Subject: ENG-Stability and Erosion Analysis of the RWCD  
Floodway Reaches 1 and 2

Date: May 23, 1985

To: Ralph M. Arrington, State Conservation Engineer

STATE		PROJECT <u>R.R.C.D. Floodway</u>			
BY <u>[Signature]</u>	DATE <u>5/23/65</u>	CHECKED BY	DATE	JOB NO.	
SUBJECT <u>Q16 VS max. S<sub>0</sub> Analysis</u>				SHEET <u>4</u> OF <u>5</u>

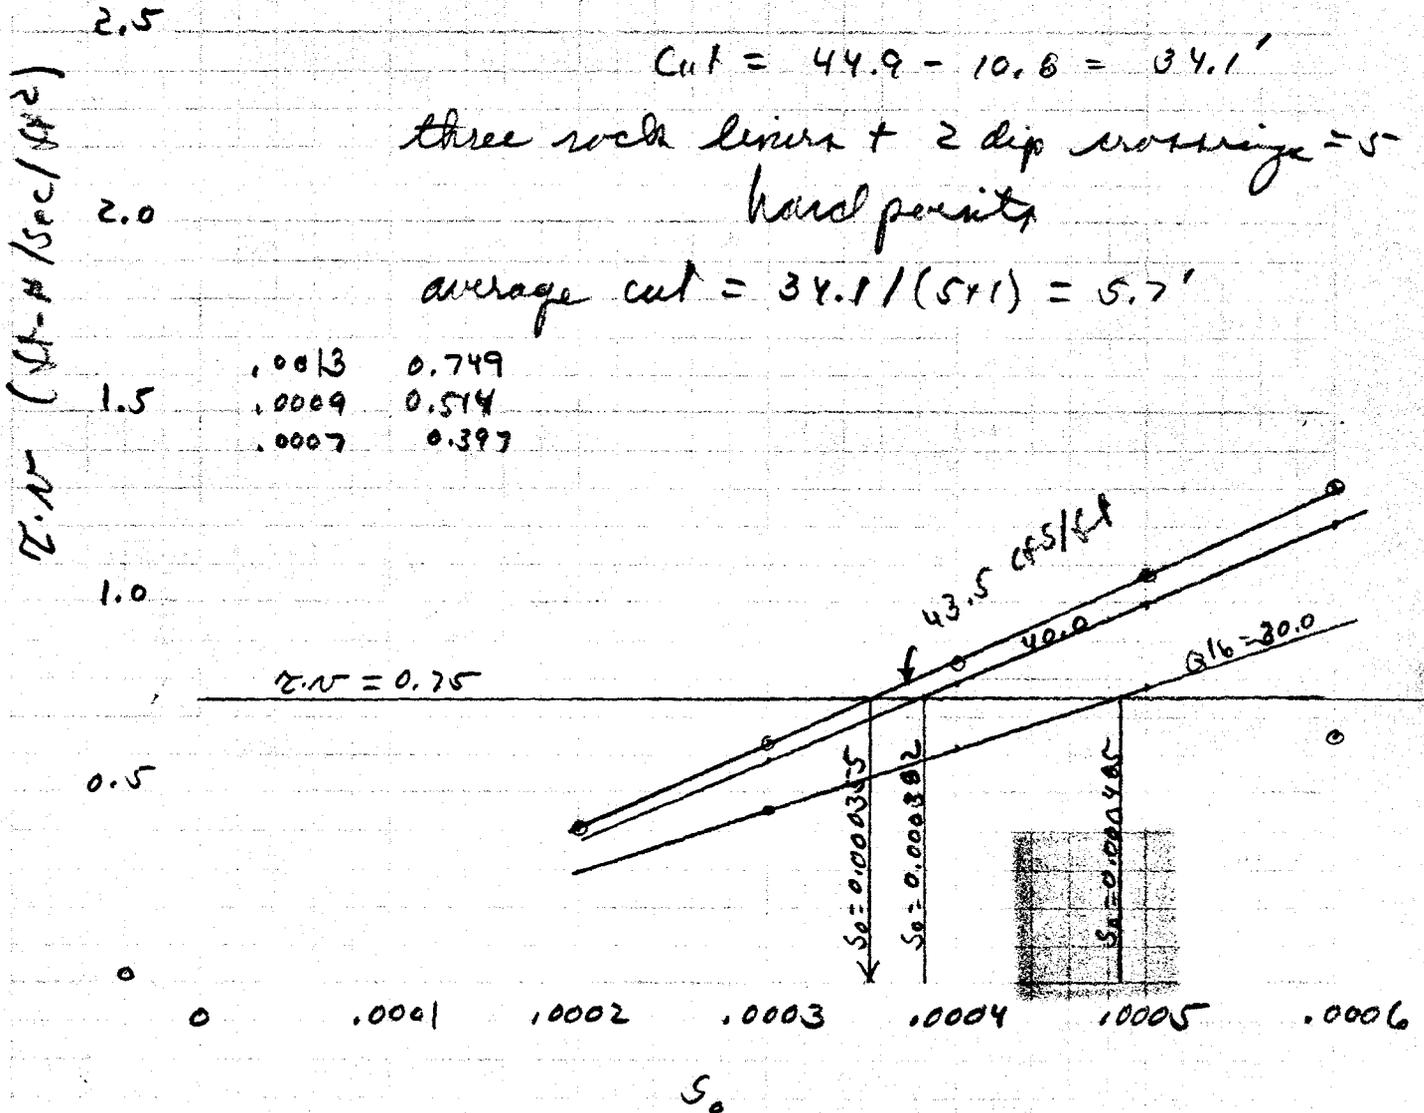
SKa	k=104
R.C. 1464700	1195.5
C.C. 1160422	1240.4
30,378	44.9
$S_0 = 44.9 / 30378 = 0.00148$

$\Delta h_{oil} = 30378 \times 0.000355 = 10.8'$

Cut = 44.9 - 10.8 = 34.1'

three rock lines + 2 dip crossings = 5 hard points

average cut = 34.1 / (5+1) = 5.7'
